DIAMANT

SERVICE

BULLETINS

**Flug- u. Fahrzeugwerke A. G.
Altenrhein**

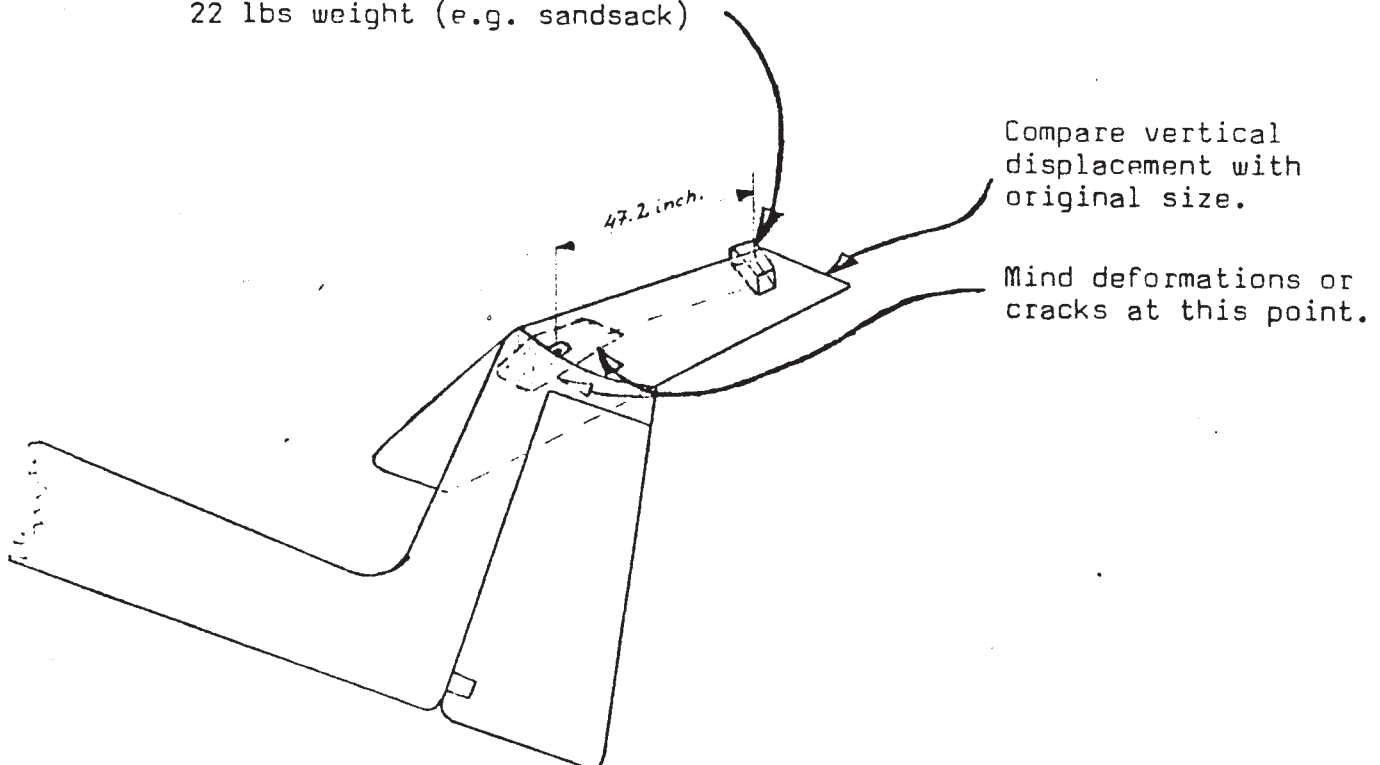
Reason : By violent turn landing damage occured on the inside web of the horizontal tail which is recognizable in a strike softness of the horizontal tail.

In a distance of 47.2 inch. (1200 mm) from the center the horiz. tail shall be loaded with 22 + 33 lbs (10 + 15 kp). The skin of the empennage in the area of the mounting is to be inspected for detached points and also for deformations and cracks.

Further, the vertical displacement of the empennage leading edge shall be mind.

22 lbs weight (e.g. sandsack)

If there is any damage on the empennage it has to be send immediatly to the nearest workshop or to FFA for repair.

Sketch "2"

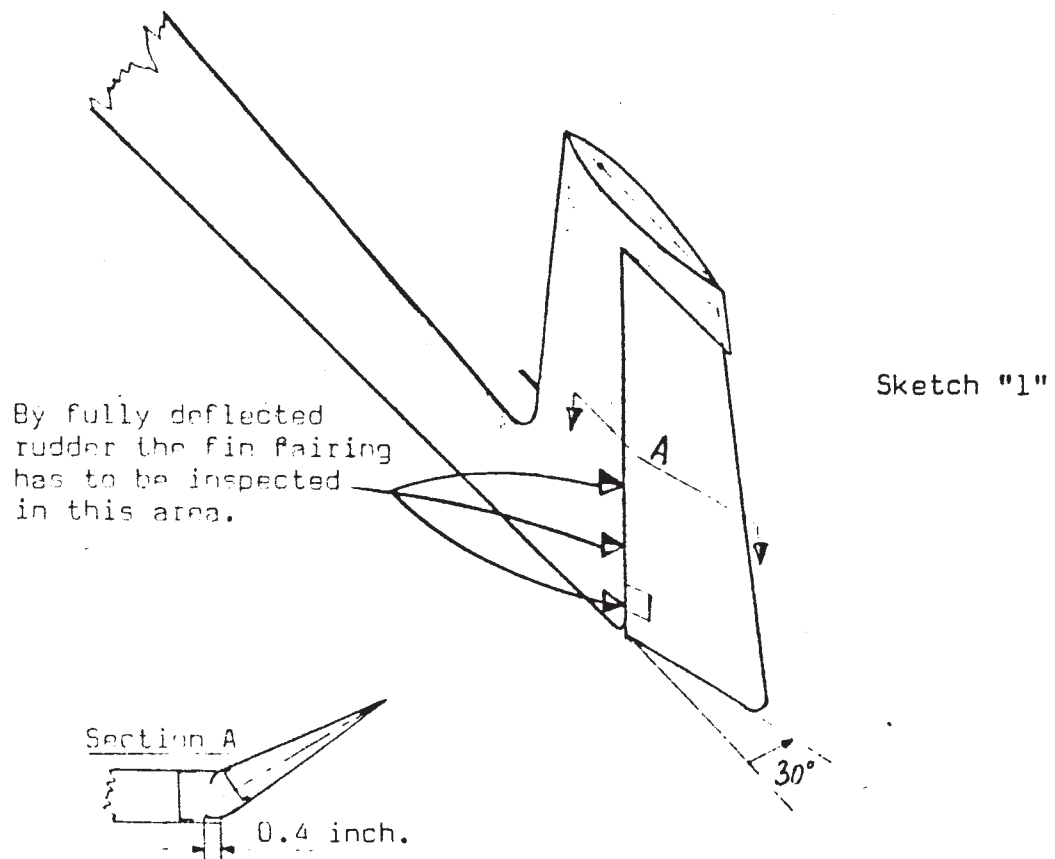
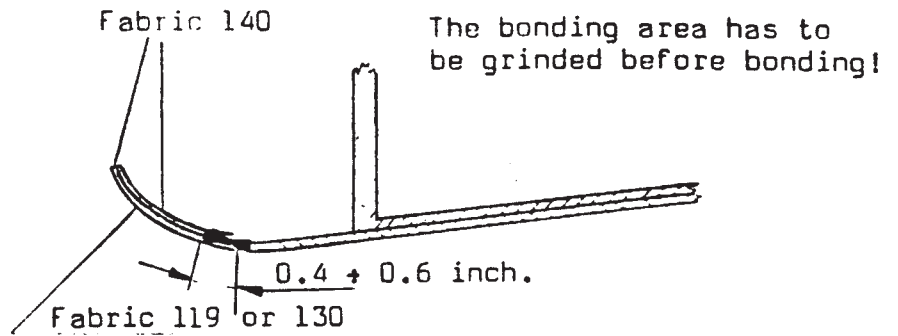
Reason : By fitting on the rudder of the vertical empennage some of the left fin hinge fairing were cut very small, so that a simultaneous pressure on the fairing and an extreme rudder position can result in their jamming.

The rudder shall be fully deflected to the right, so that the left fin fairing can be inspected in accordance to the sketch "1".

If the covering is smaller than 0.4 inches (10 mm) the rudder nose has to be lengthened with 3 strips of fiberglass as shown in sketch "2". The bonding area has to be grinded before bonding.

Performance : The repair has to be done by a skilled worker for fiberglass material.

HOEHENSTEUERUMLENKHEBEL
ELEVATOR BELLCRANK

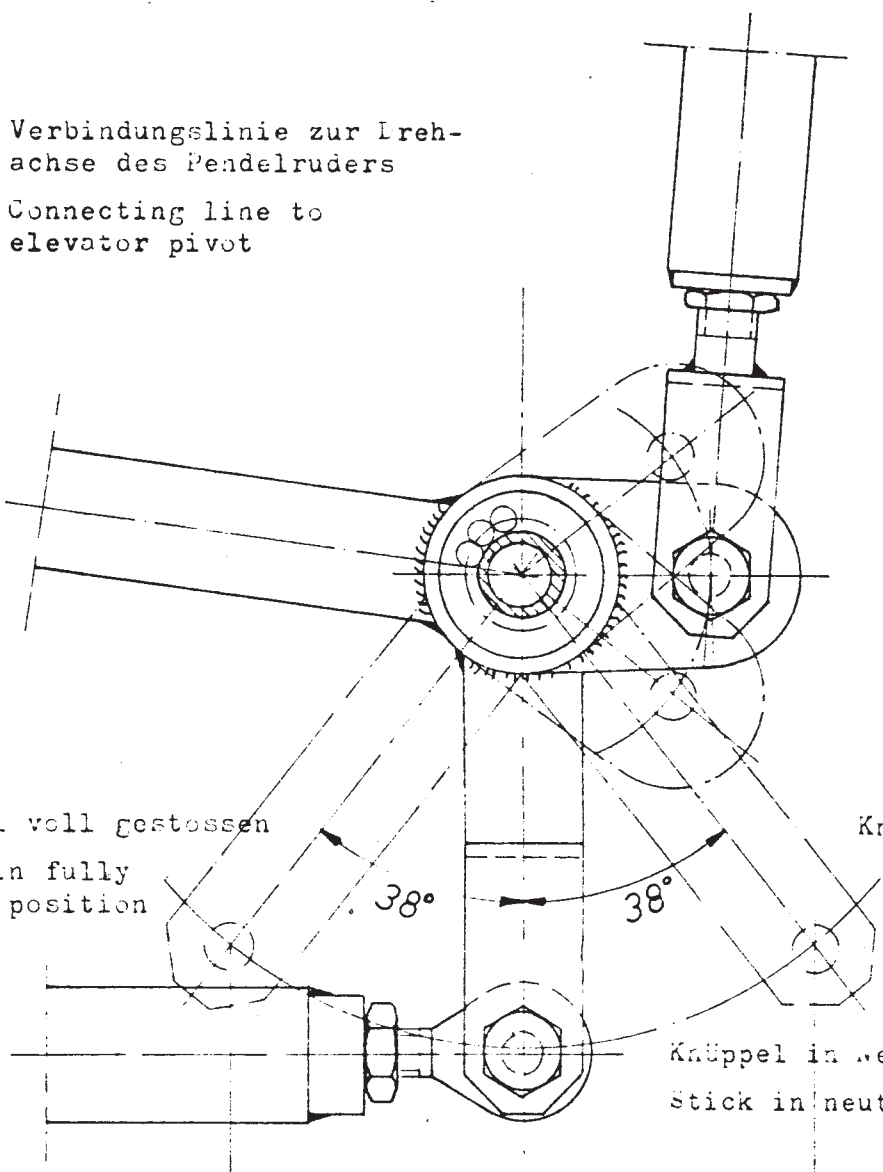
Reason: We have experienced a failure of the threaded end of the bearing rod end at the end of the elevator pushrod in the fuselage where the pushrod is connected to the bellcrank at the base of the fin.

Due to improper adjustment of the elevator pushrods in the fuselage, the position of the bellcrank lever was such that the fork of the bellcrank touched the threaded end or the threaded bushing in the fully pulled position. The threaded end was deformed and eventually failed.

Check if the driving lever of the bellcrank lever is in vertical position when the stick is in neutral position. The driving lever should attain the full travel as indicated on the attached drawing.

If the travel has to be adjusted, proceed as mentioned in the REPAIR MANUAL, Section 8.5.

Check threaded ends for deformation and indentations and ensure that they are screwed in far enough and all lock nuts are tight and lock washers installed as required.

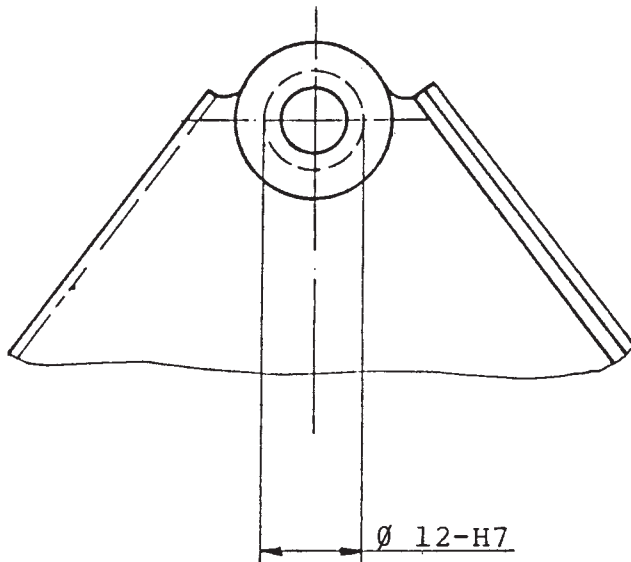
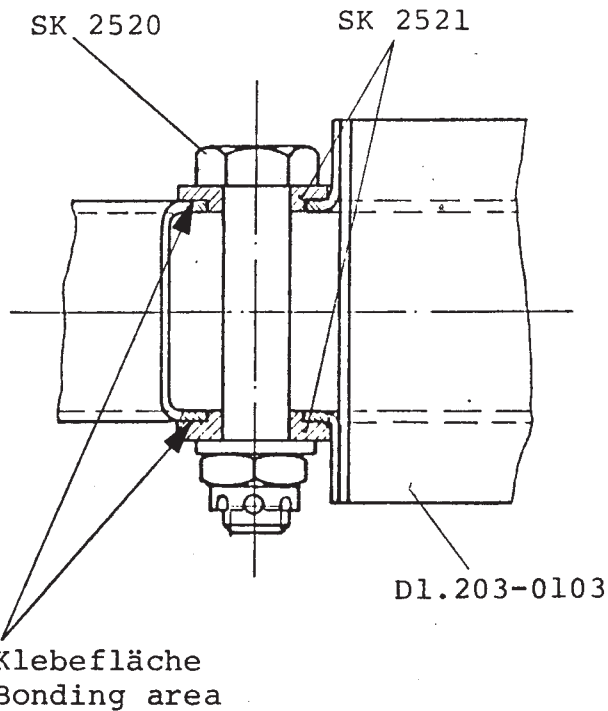
Reason : The stick control of one DIAMANT sailplane had too much play. The result of an exact investigation was showing wear of the stick bearing in the torsion tube.

1. Inspect stick control for excessive play immediately after receipt of this Service Bulletin.
2. If the stick bearing shows normal play the inspection must be repeated every 50 flight hours.
3. If the stick bearing shows play accomplish the modification in accordance with para 4 before the next flight.
4. Modification:
The present two holes in the torsion tube D1.203-0103 must be drilled and reamed to the diameter of 12-H7 ($12 + 8,018$ mm).
According to the attached drawing, two bushings SK 2521 have to be bonded into the torsion tube. Due to the new dimension of the bearing depth, the pivot bolt D1.203-0106 must be replaced by a new bolt SK 2520.
5. The inspections according to para 2 are no longer necessary if modification has been carried out.

1. Klebeflächen von Farbe, Oel, Fett und anderen Rückständen reinigen.
2. Klebemittel auftragen.
3. Lager-Büchsen einpressen.
4. Ueberflüssiges Harz von der Innenseite entfernen und Bohrungen sauber halten.

1. All surfaces to be bonded must be free of paint, oil, grease or other foreign substances.
2. Apply the adhesive.
3. Press in the bushings.
4. Keep the bore of the bushings and inner surface free of adhesive.

Zeichnung zu Diamant-Bulletin Nr 5
 DRAWING TO DIAMANT-BULLETIN NO 5

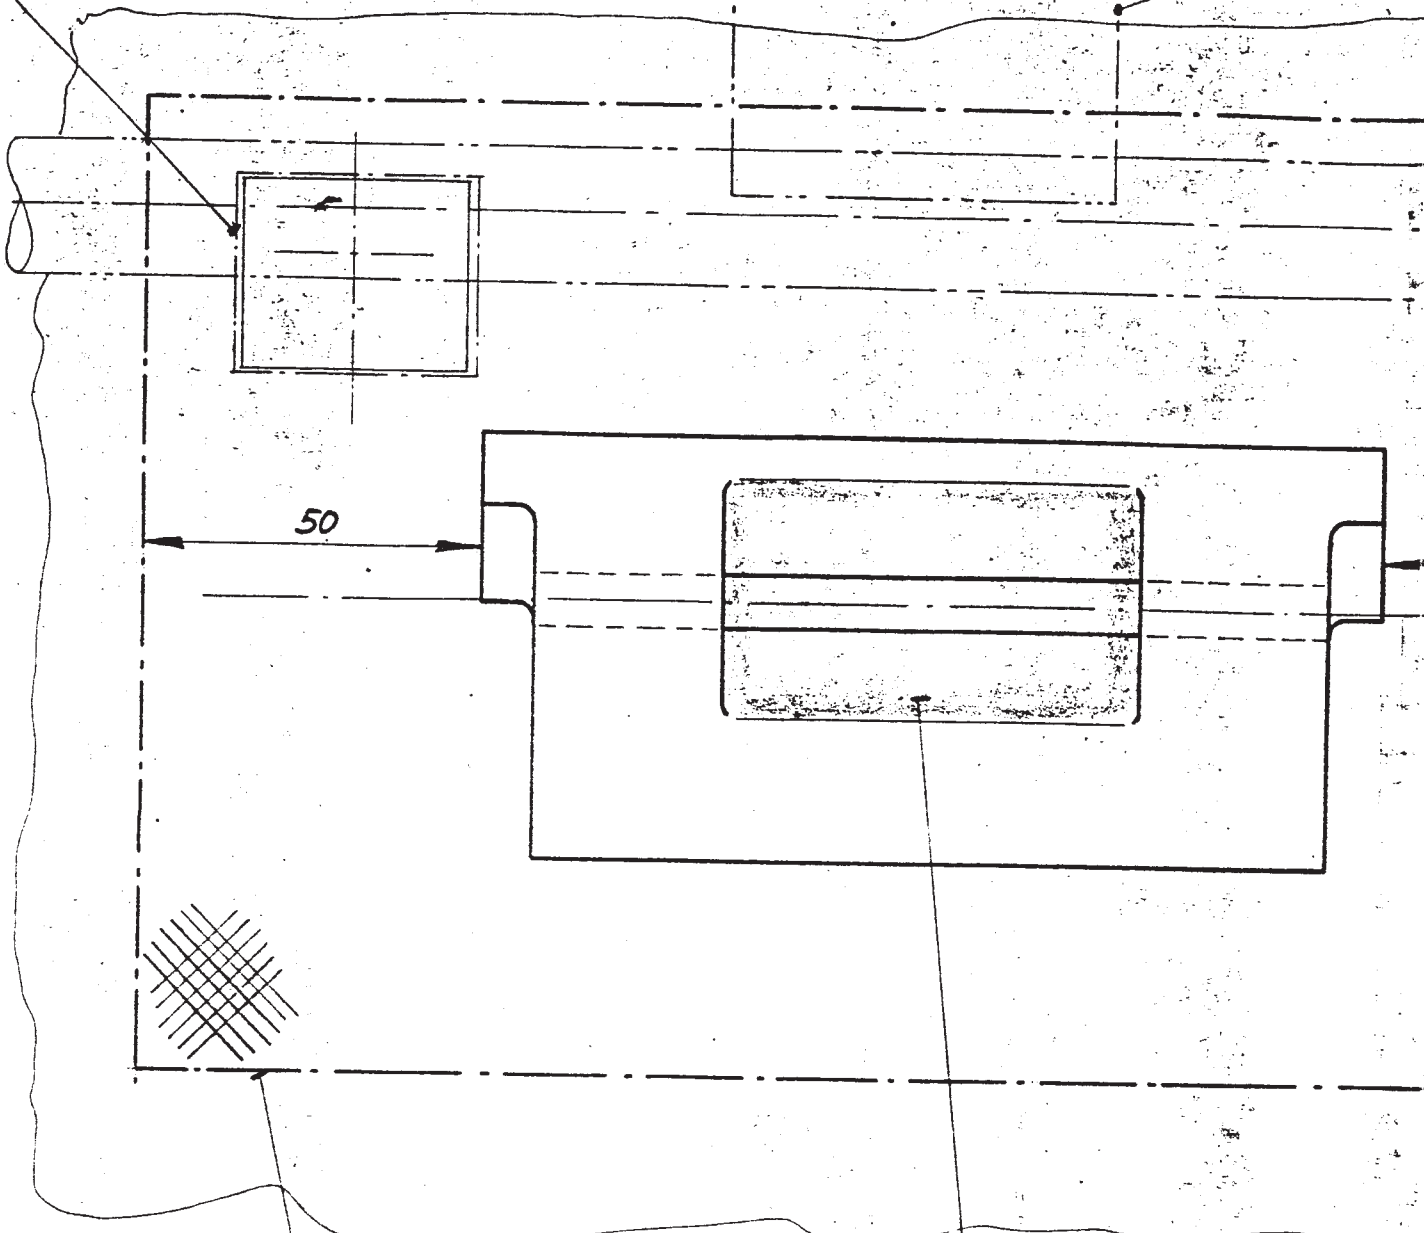
REASON : The lower harness attachments of a DIAMANT sailplane came loose due to an incident. The investigation showed that the bonding of the attachments was insufficient.

A reinforcement of every lower harness attachment is required since checking the bonding of all active DIAMANT sailplanes is not possible.

REQUIRED ACTION : Two each fiberglass clothes 140 diagonal have to be laminated across the harness attachments in accordance with the attached drawing SK-HBV 189:

1. Remove LH and RH sidewall panels.
2. Remove seat upholstery as far as necessary (glued).
3. Remove lower harness.
4. Remove attachment support Dl.206-0510 of long trim springs.
5. Disconnect trim lever Dl.206-0501 at pivot point.
6. Remove aileron and flap bellcranks at the lefthand side of the landing gear. Tying the push rods up gives sufficient space for the bonding procedure.
7. Sand fuselage and harness retaining area to the size of the reinforcement laminate.
8. Cut to size glass clothes in accordance with the attached drawing SK-HBV 189.
9. Laminate tailored fiberglass clothes with Araldit resin LY 554 (5 parts) and Araldit hardener HY 554 (1 part). Minimum temperature for bonding procedure is 20°C = 68°F.
10. Cut out opening for harness attachment after curing.

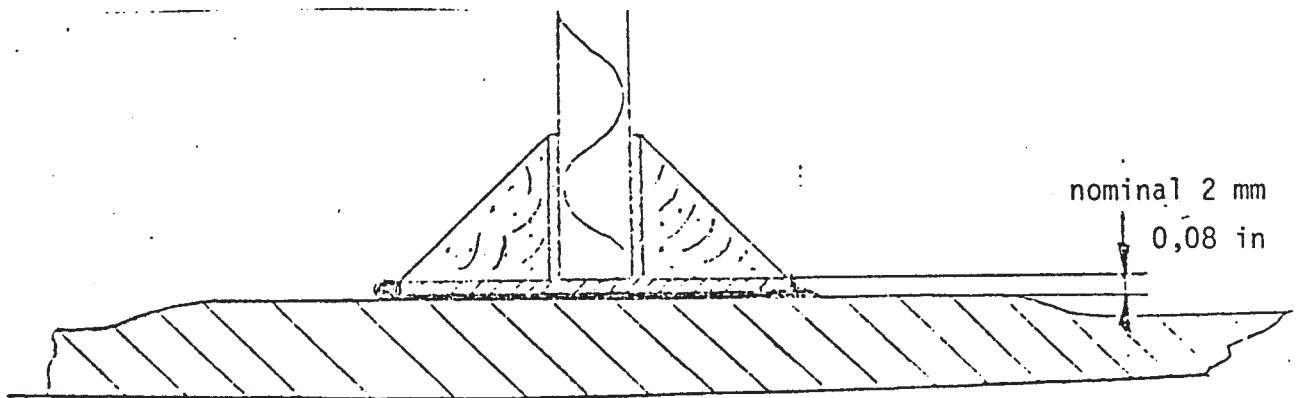
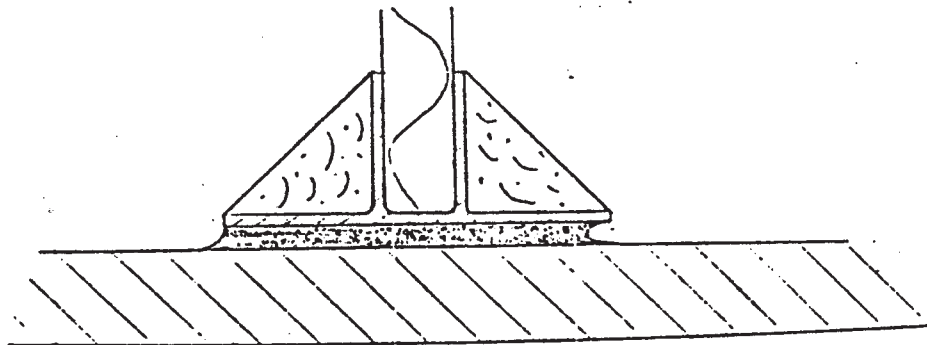
2.3.1 The bonding may be considered to be good if the resin has oozed, usually in drops, out of the bonded joint, see fig.1

2.3.2 Receding glue lines must be viewed with suspicion (see fig.2)
Refer to manufacturer for further instructions.

LH WING BOTTOM

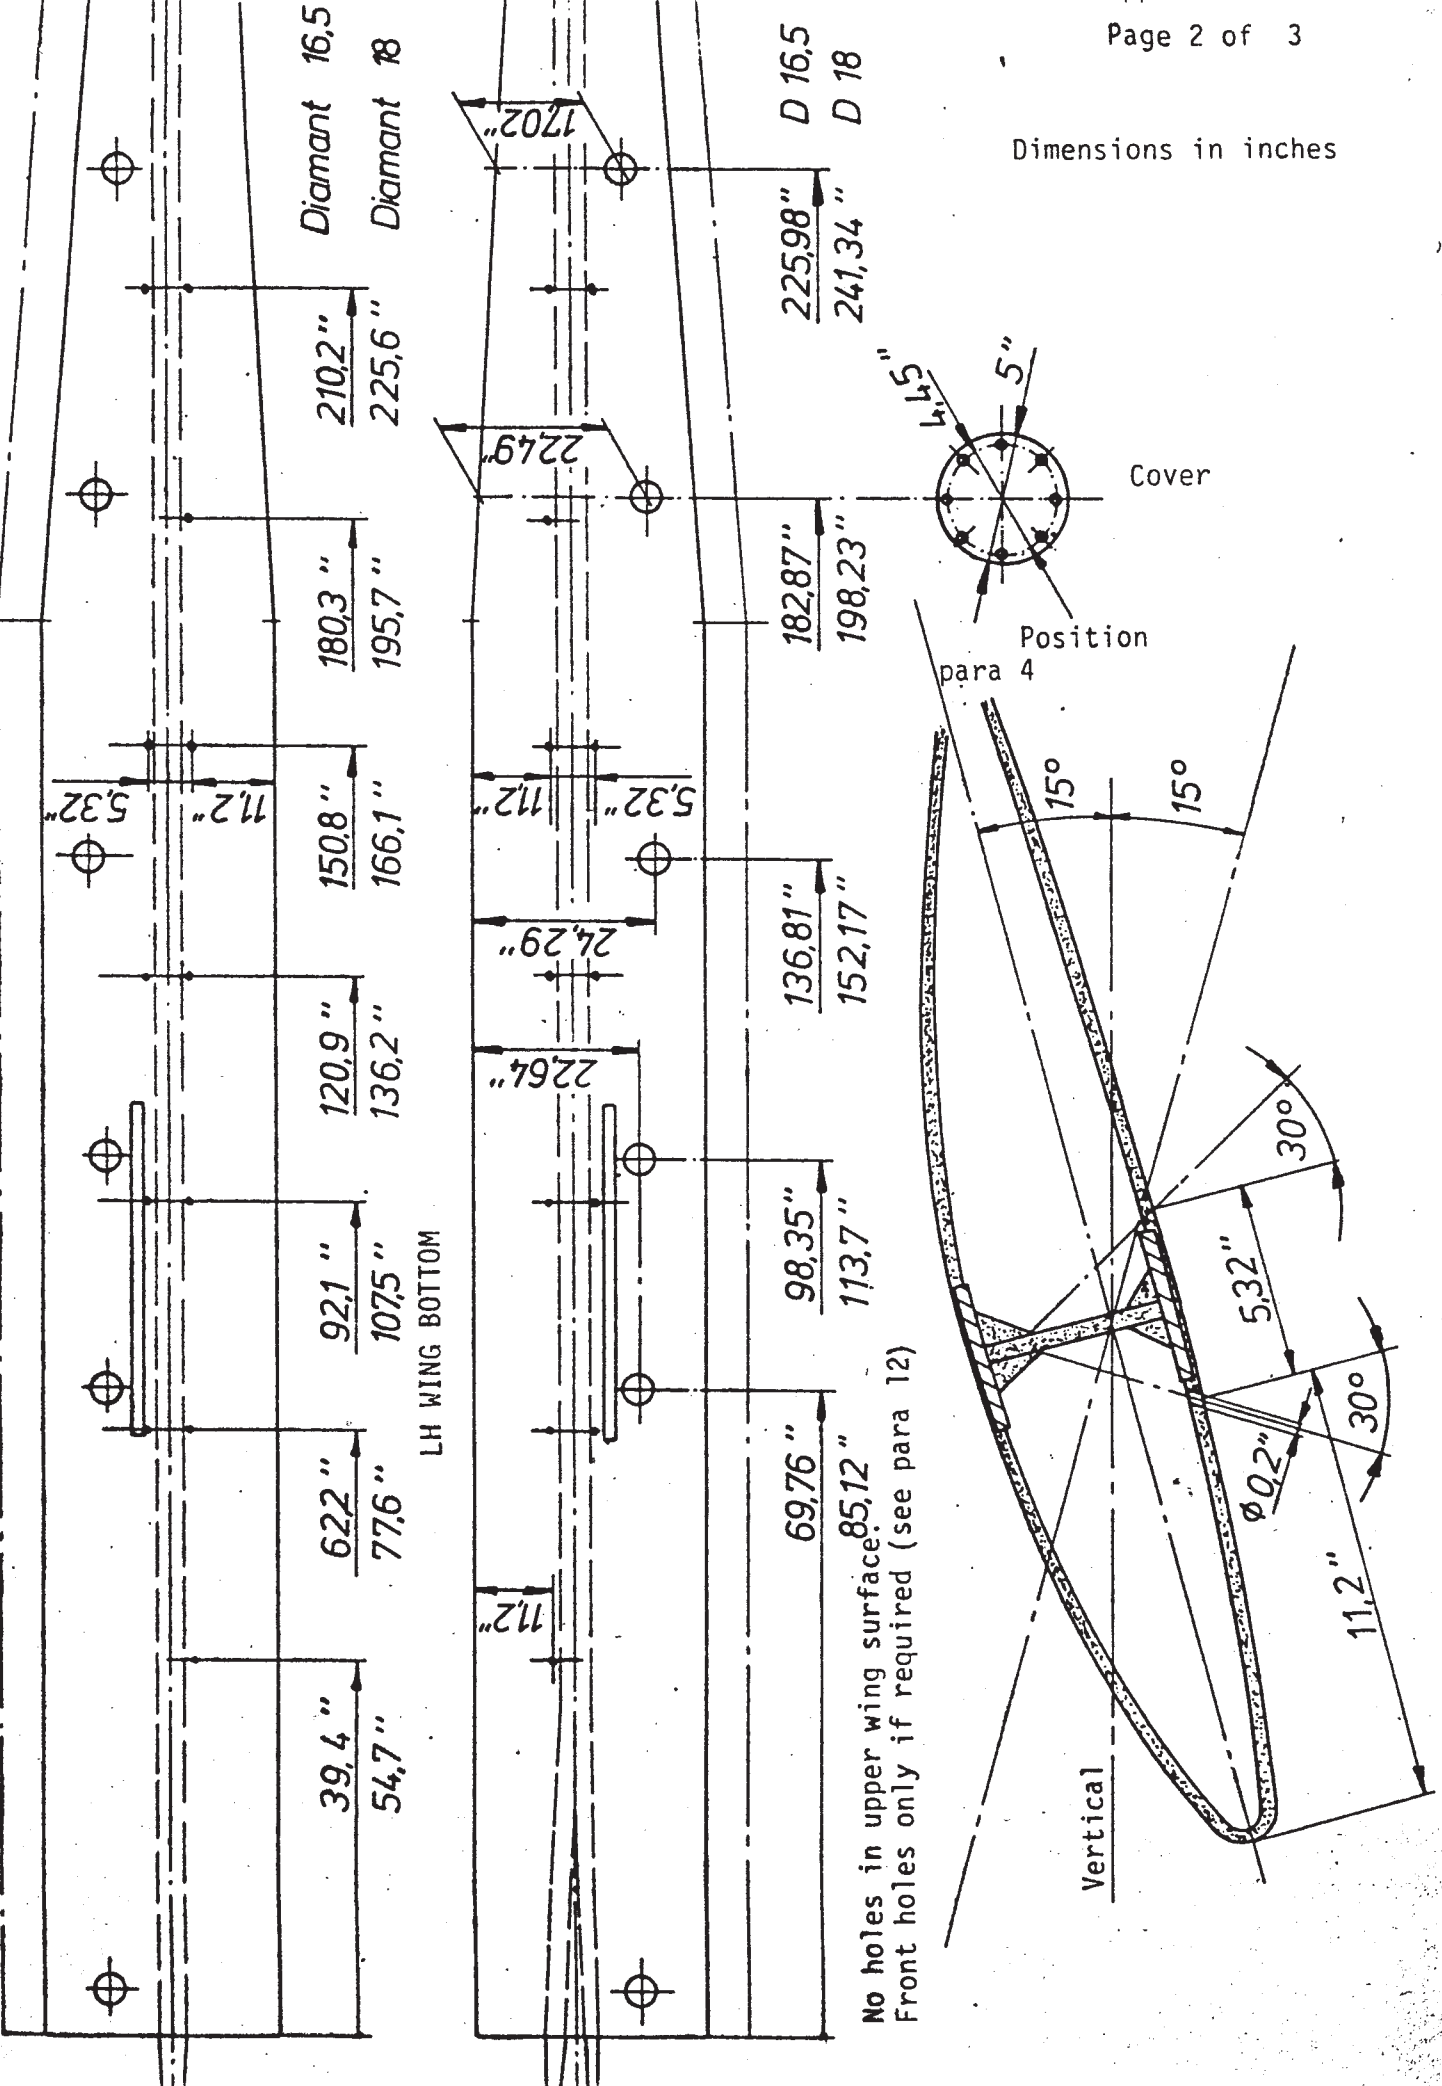
1. Trestle up wing upside down.
2. Drill 0,2 in dia. holes at 30 degrees to lower surface according to figure on page 2. Remove covers (except cover near root rib).
Exception: Regions accessible through probe drillings and/or access holes of 2.1, Appendix II.

No holes in upper wing surface.
Front holes only if required (see para 12)

11. After curing tilt wing back to 75 degrees and apply resin mixture to the leak point using nearest hole. Leave for 4 hours.
12. If gap between web and hat section is existing on forward face of spar (visible through hole in root rib), drill holes in front of spar, turn wing to 75 degrees nose up position and repeat procedure of para. 6 to 11 using the forward holes. There should be no more leakage of resin. Keep wing in this position for 4 hours at 20⁰C minimum.
